## Feedback in response to the public consultation on voltage service and reactive power control review (CREG incentive 2023)

BOP would like to make some suggestions and provide feedback in response to the public consultation of the voltage service and reactive power control review as launched by Elia on 28<sup>th</sup> of September.

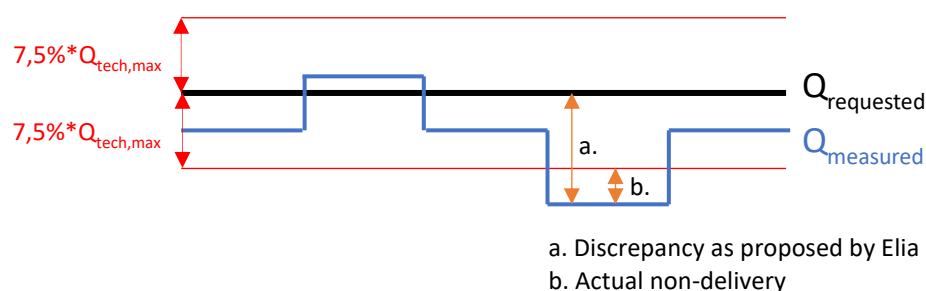
The discrepancy as proposed by Elia in proposal 2 is defined as the delta between  $Q_{\text{requested}}$  and  $Q_{\text{measured}}$ , which disregards the tolerance band of 7,5% described in section 4.1.2 of the consultation (see a. in the figure below). Since operation within the tolerance band is compliant, any penalty should only be calculated from the edge of the tolerance band around  $Q_{\text{requested}}$  and not from  $Q_{\text{requested}}$  itself (see b. in the figure below). This to account for the contractual performance requirements, and the technical measurement differences which have been highlighted above.
